RE: RC235259 – Upper Sefton Road

Proposed Solar Farm - 87 Upper Sefton Road, Ashley, Canterbury
Graphic Attachment to Landscape Assessment Report

Project		
Proposed Solar Farm		
Address		
87 Upper Sefton Road, Ashley		
Client		
Solar Bay Ltd		
Document		
Graphic Attachment to Landscape Assessment Report		
Status		
For Resource Consent		
Revision		
1	For Resource Consent	11.10.2023
2	RFI Response	14.05.2024
3	RFI Response	08.08.2024
4	RFI Response	24.09.2024
Prepared By		
Rough Milne Mitchell Landscape Architects Ltd		
Project Number: 21322		
Author: Zoe Cox and Paul Smith		
Peer Reviewed: Nikki Smetham

Landscape Mitigation Plan - Focus Plan

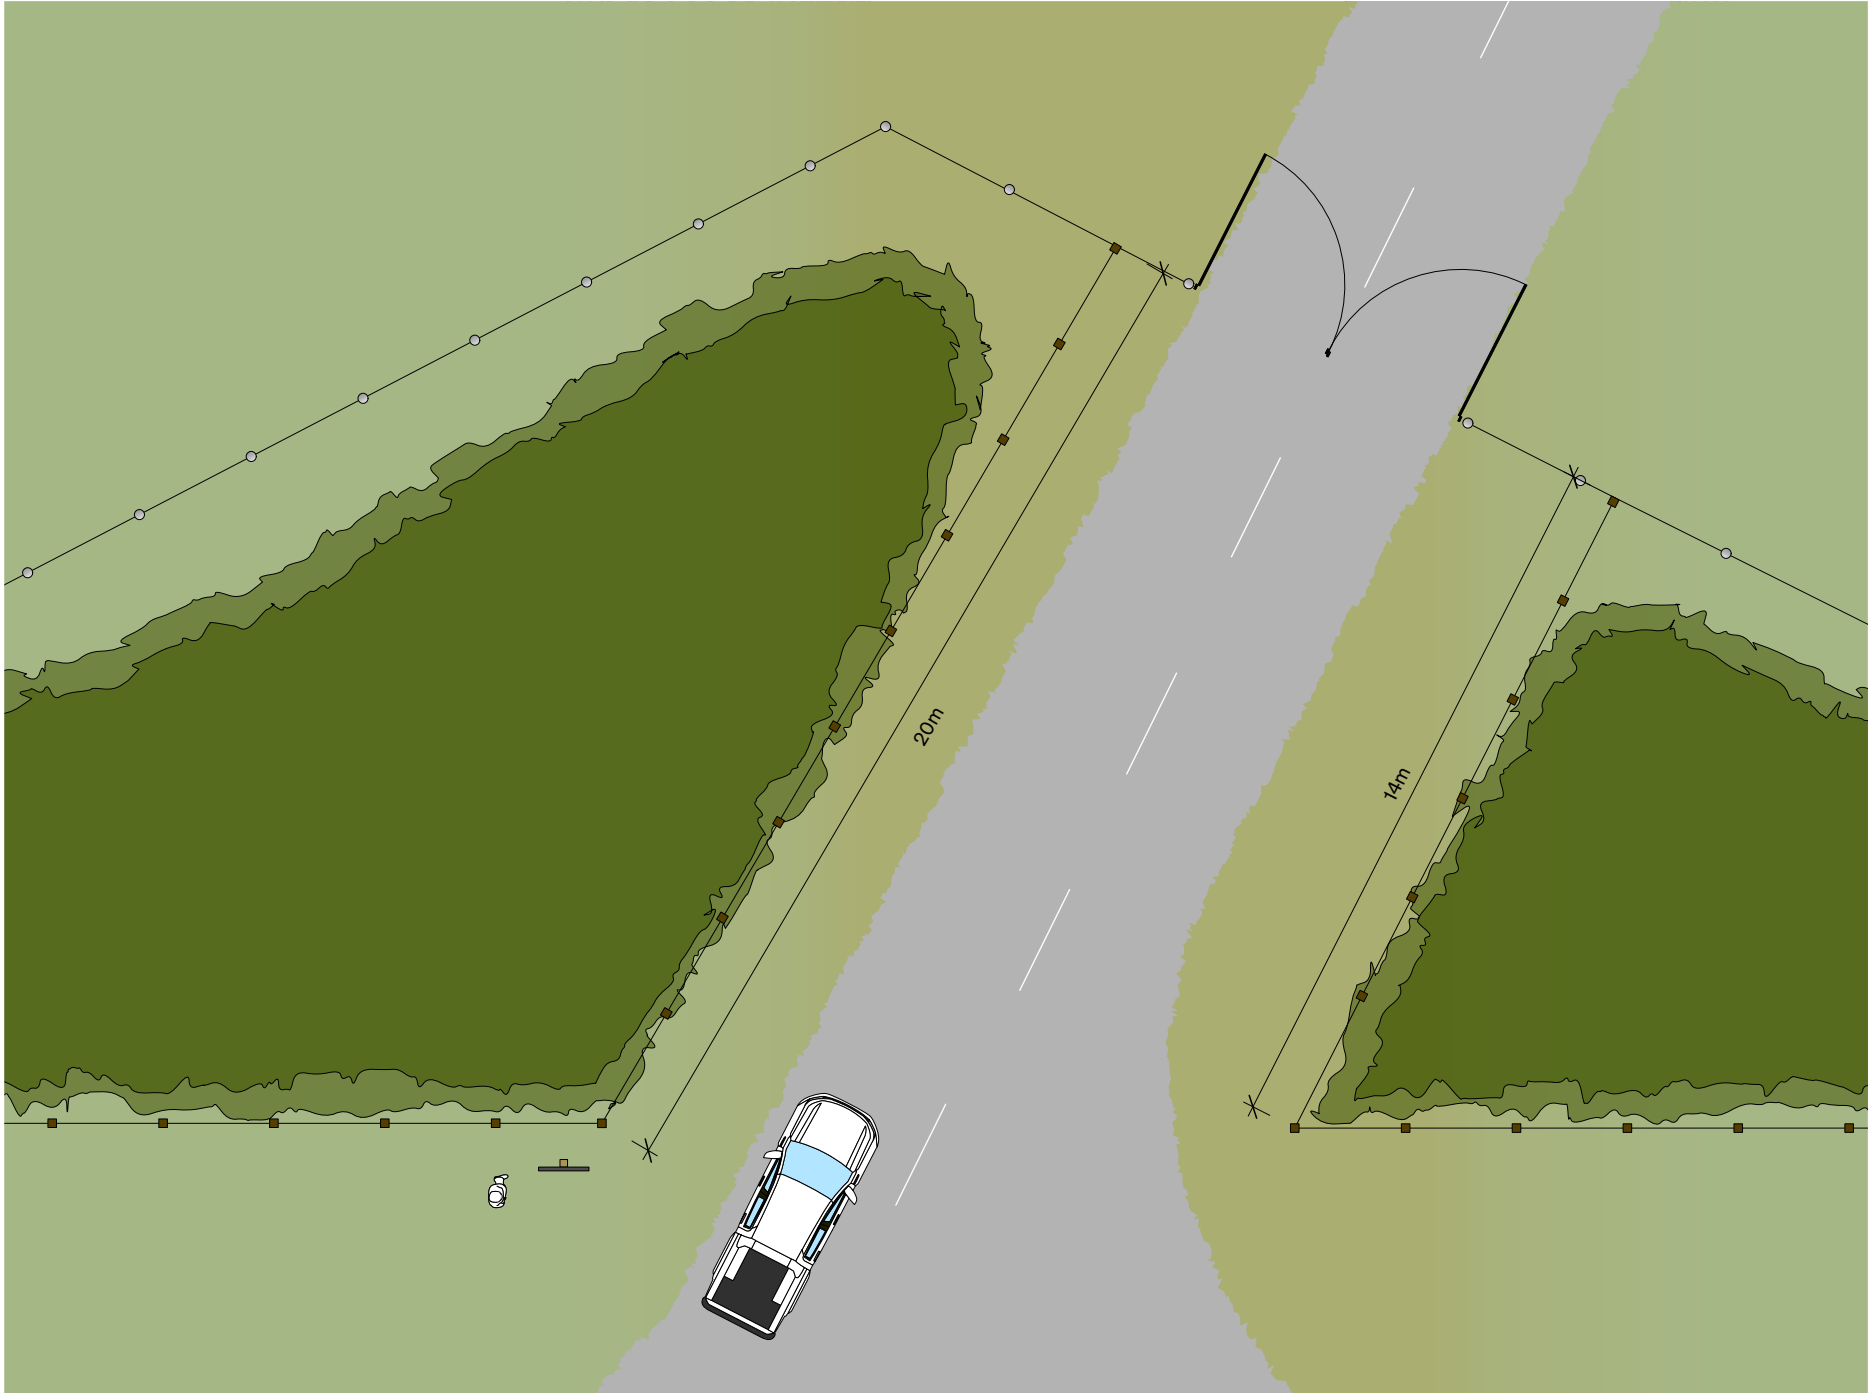
The landscape mitigation plan has been updated to capture all of Mr Jade McFarlane's comment, a labelled 1 – 4 and annotated on the attached PDF.

Page 10 - Additional Comment 4. The landscape plan has been updated to ensure that proposed vegetation within 12m of the transmission lines centreline do not grow over 2m tall. The condition needs to be updated to reflect this. The plant and their locations are in accordance with the attached document that Transpower has prepared.

9. The shelterbelt will be irrigated via an automatic irrigation system for the first 5 years following planting.
10. The shelterbelt and native vegetation along the sites northwest boundary will be maintained at a minimum height of 6m.

11. The shelterbelt and native vegetation along all other boundary lines and illustrated on the landscape mitigation plan will be maintained at a minimum height of 4m.

Landscape Mitigation Plan - Cross Section A

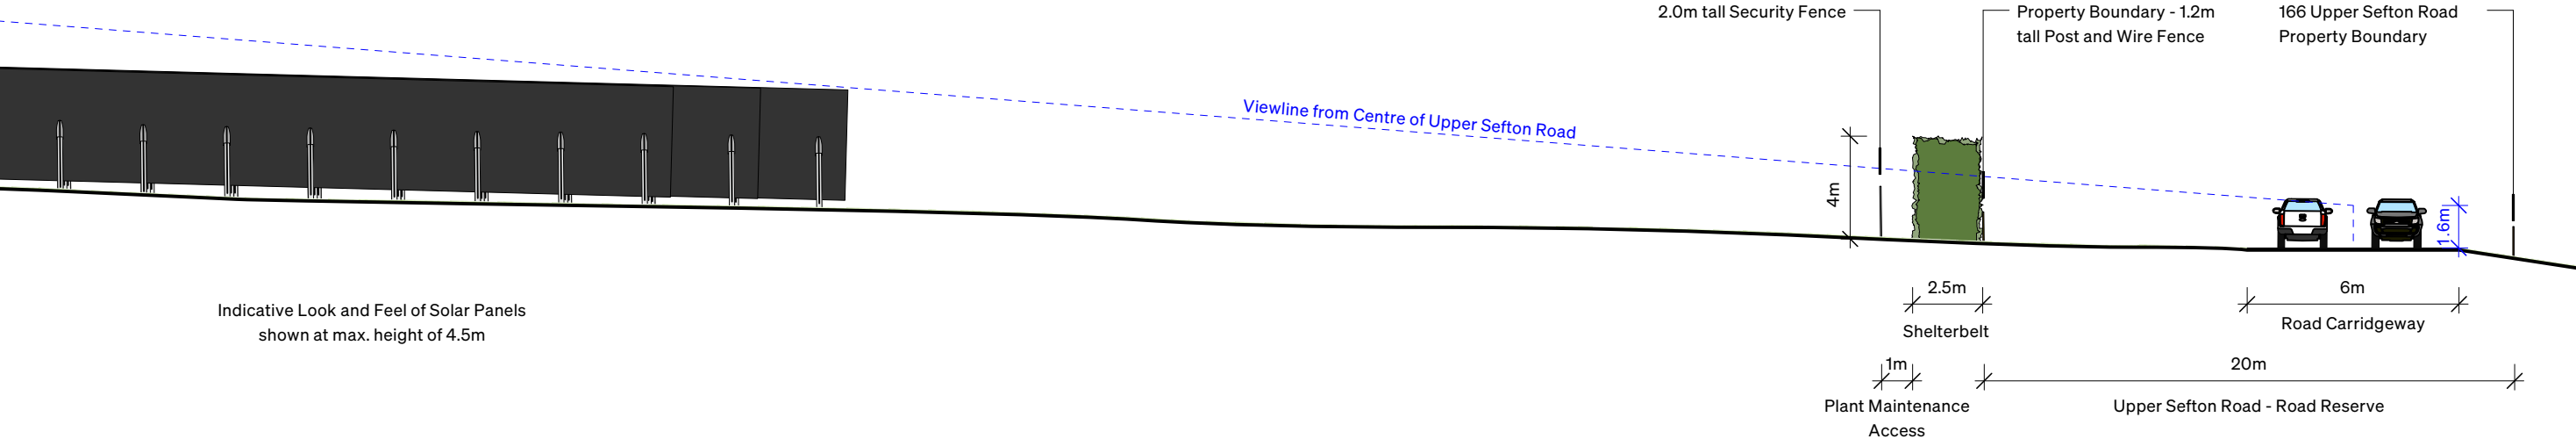
Page 7 – Undulating Land. Two cross sections have been included in the Graphic Attachment to assist in illustrating the way in which the proposed boundary vegetation will visually screen the solar panels from the adjacent stretches of road.

Figure 11a: Sketch of wind affected rainfall and the reduced effect of ground shielding

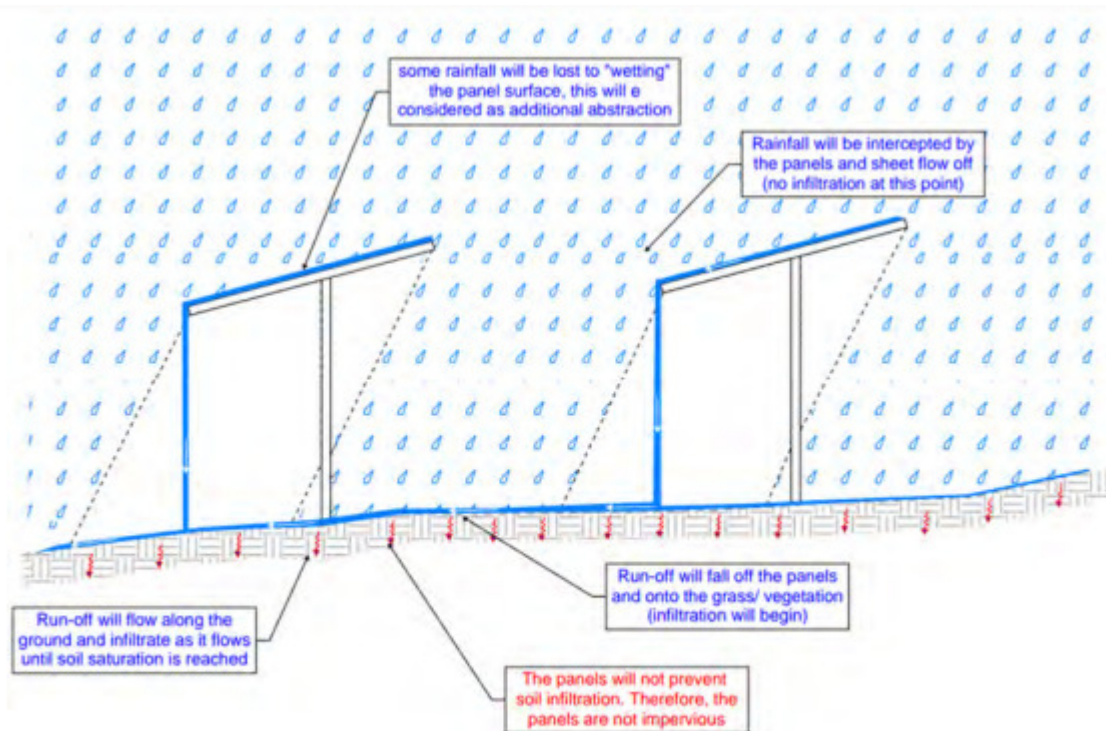
However, as shown above, the water will fall in the same location underneath the lower edge of the solar panel whenever it rains at the site, referred to as the dripline. The repetitive effect of water falling in the same spot may cause erosion directly under the solar panel edge. If this is left unaddressed soil material will be transported from the site, causing pollution within the watercourses. See below our concern:

Gary mentioned that onsite vegetation will reduce velocities of the runoff, however, directly after construction the site will require a period for vegetation establishment to allow time for the grass to grow. Monitoring for erosion and ground stabilisation may be required, especially under the lower edge of the solar panels.

In response to Council's concerns regarding the drip line and the potential for erosion. Detailed design will assess and mitigate the concentration of stormwater flows throughout the Site. Stormwater controls may include:

- Construction in accordance with an Erosion and Sedimentation Control Plan
- Maintaining adequate vegetation cover
- The construction of clean water swales to capture and convey stormwater to existing outfalls,
- Low-level bunding, for example alongside access tracks to impound and slow stormwater flows
- Attenuation devices such as localised ponds or structures, if required, in specific locations, but located so as not to impede natural flow paths.

CROSS SECTION 87 UPPER SEFTON ROAD CULVERT

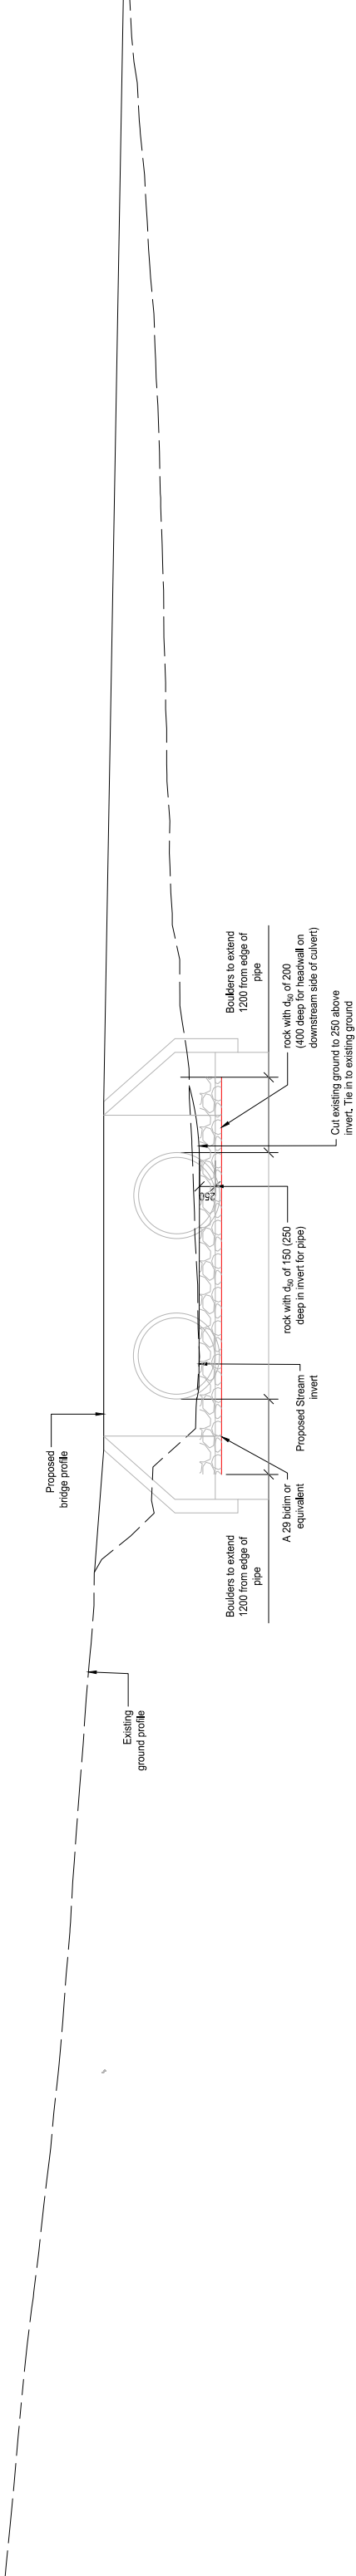
Please find link below to a dual culvert design for the access across the drain. The sub-catchment area for the culvert is 128.5916 ha. Assuming a 50-year design life, RCP of 8.5 to 2081-2100 and a 10 year ARI, the worst rainfall event is 30 minutes which gives a maximum flow through the culvert of 6.225 m³/s.

Note that this design was chosen as there is a large embankment step up that we needed to build up to. There will be a road that will fill in some of the channel to the culvert. We have not shown the road. It is shown in the cross-section of the drawing.

1. *The consent holder shall install an access culvert across the Site drain at the approximate coordinates 5209870mN 1568561mE as shown on the approved plan (XXXX). The culvert shall pass a minimum flow derived from a 10-year ARI rainfall event to RCP 8.5, year 2081 to 2100.*
